Addendum 1

Dated: October 8, 2026

CONTRACT DOCUMENTS FOR
Zone 2 Reservoir Electrical Service

Title Sheet and
Single Line
Diagram

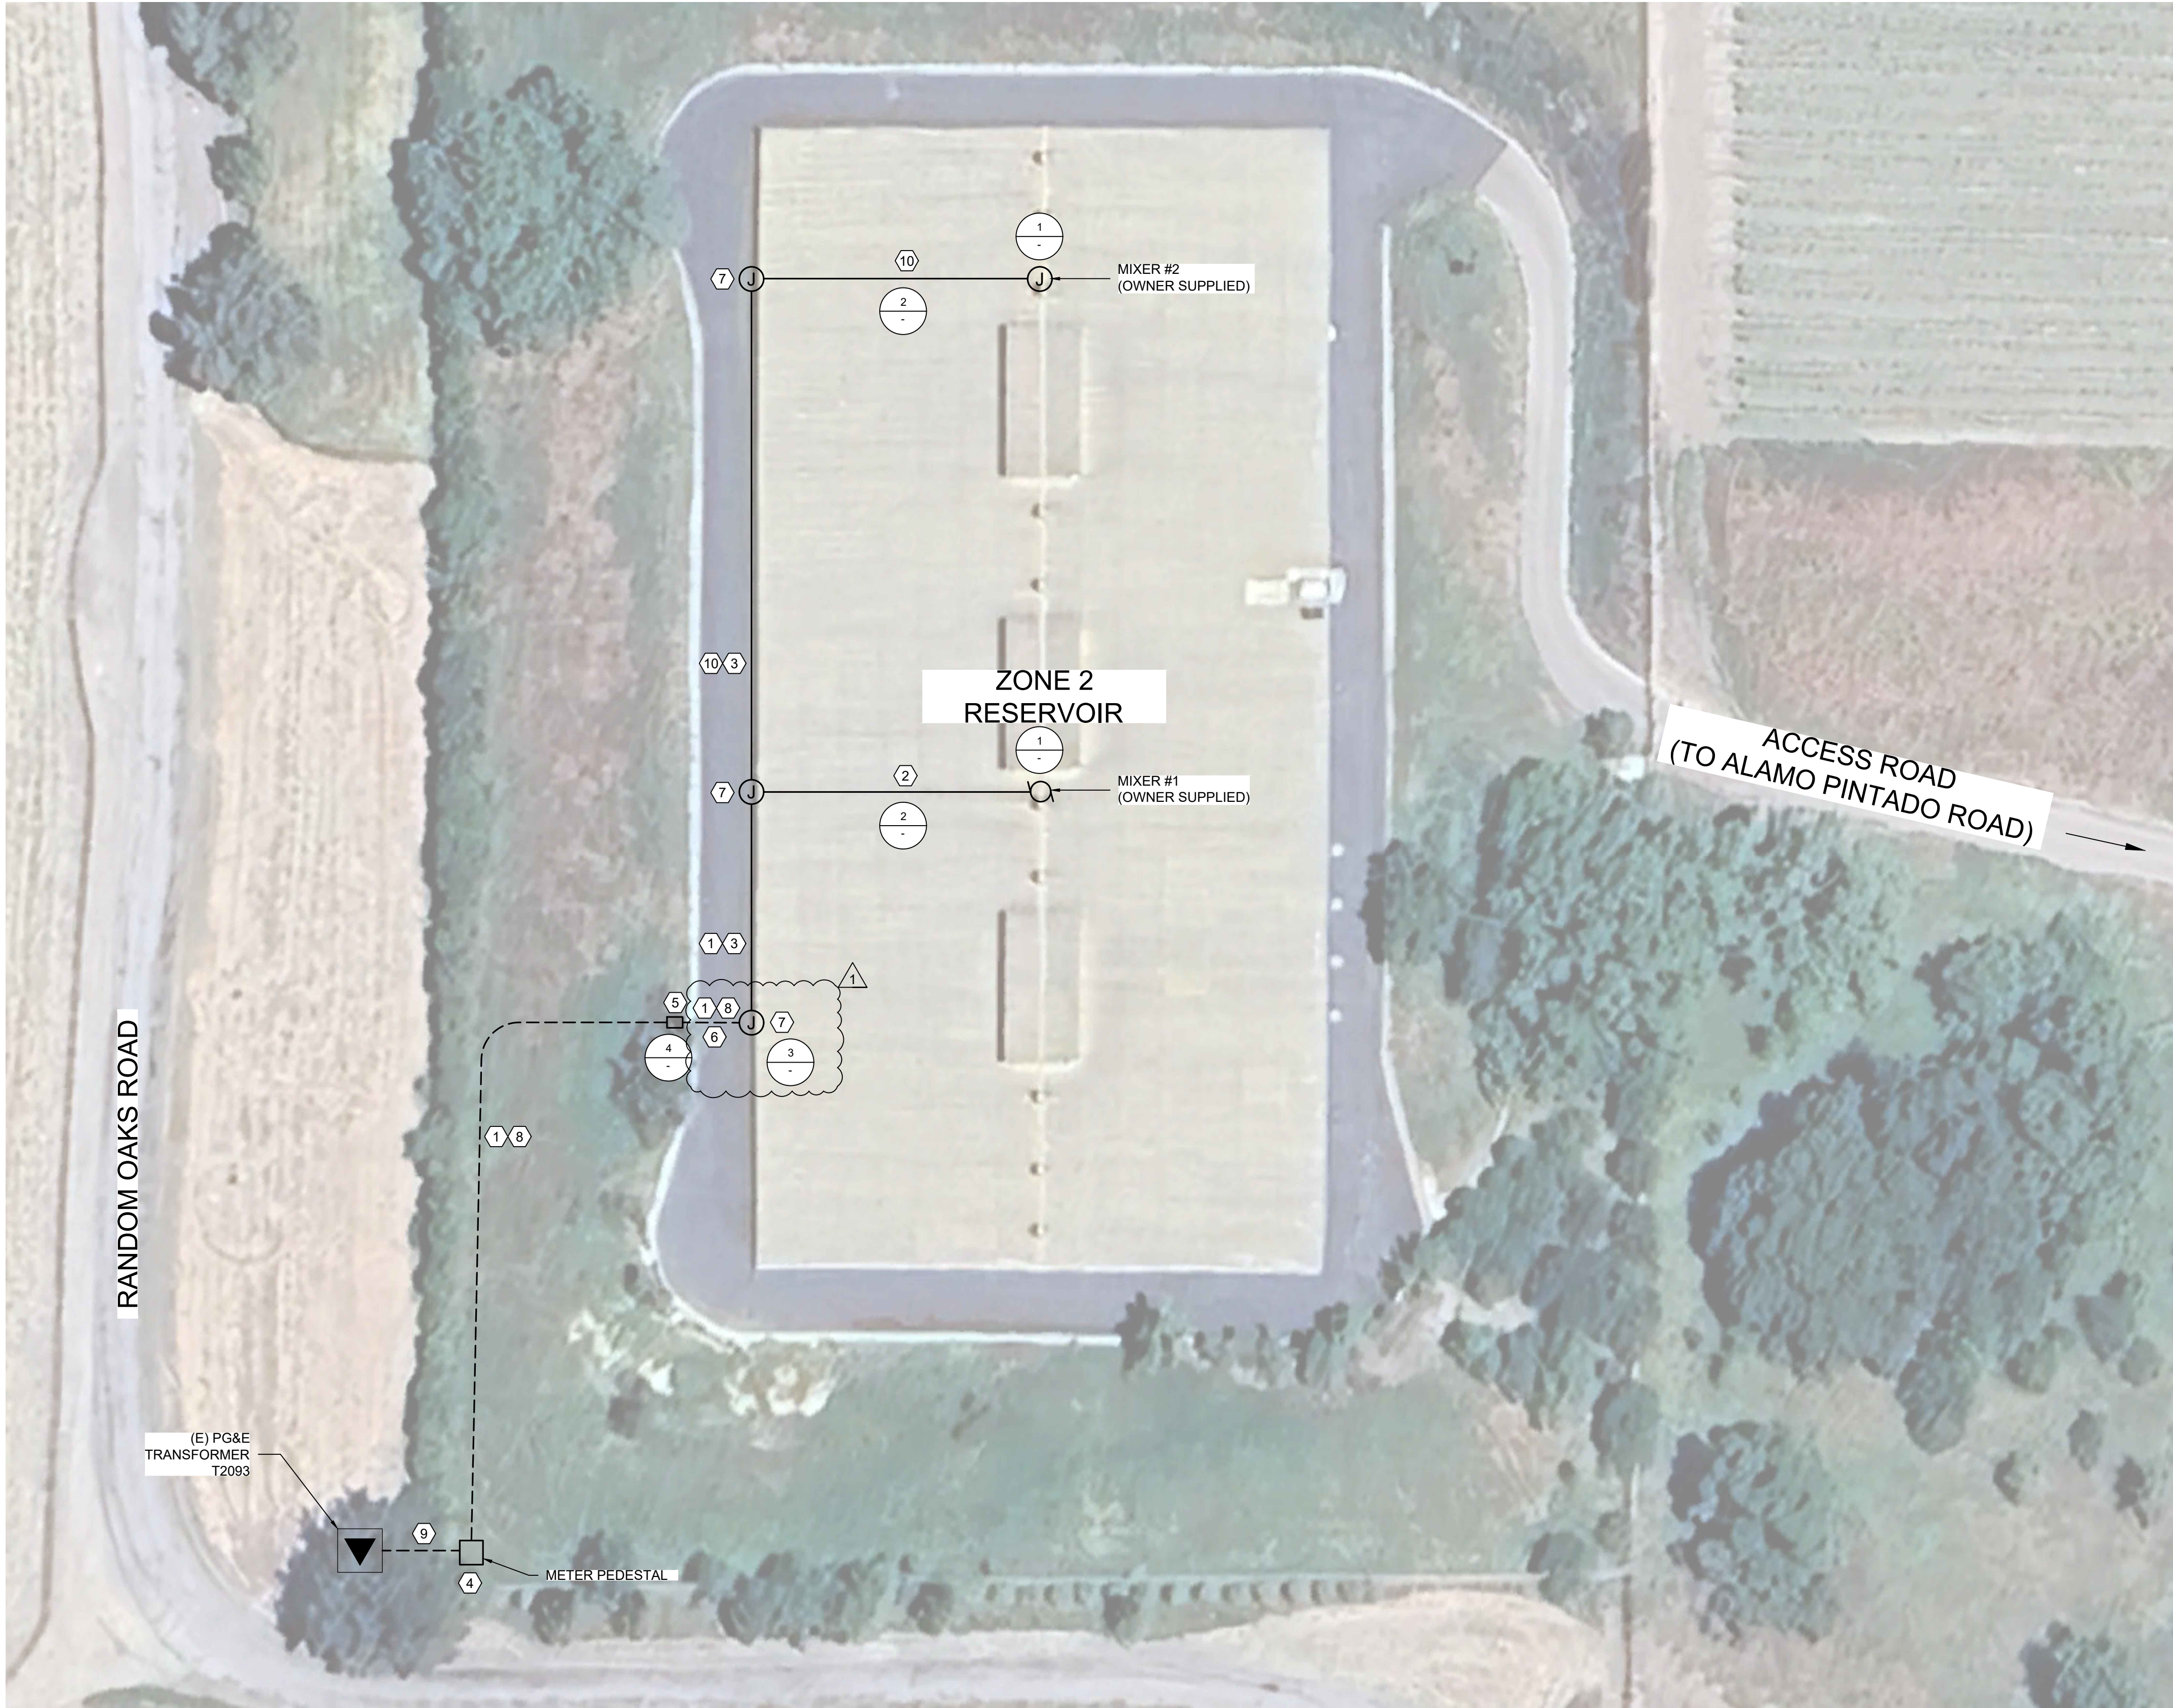
Project Drawings – Page E1 – Single Line Diagram

Revised Single Line Diagram. Provide GFCI breakers for each mixer.
